MEMORANDUM

TO: District of Columbia Zoning Commission

DATE: September 26, 2022

SUBJECT: Public Hearing Report for Zoning Commission Case No. 22-06, Consolidated Planned Unit Development and Related Map Amendment from MU-12 to MU-9A, 899 Maine Ave. SW

Exhibit 38A5 – Sheets 66, 72 - Portions of Streetscape Plan
Additional landscaping within public space shown would be either maintained and/or added to the Maine Avenue and 9th Street frontages.

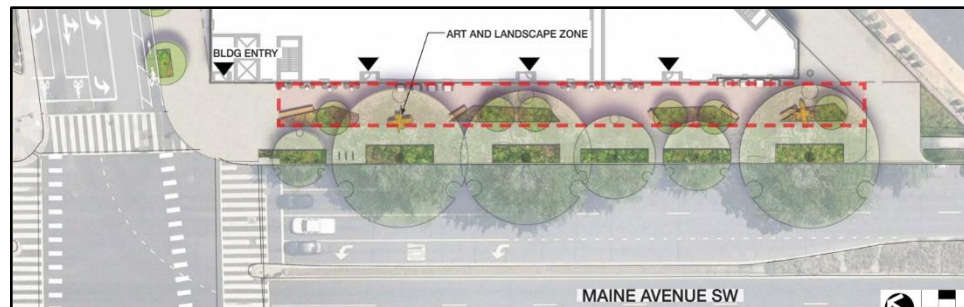
The project includes significant streetscape improvements including wider sidewalks, and street lighting fixtures ([Exhibit 38C](#)). The Project would provide new landscaping and seating around the site, including adjacent public space along Maine Avenue, public art, and other areas to be dedicated to seating.
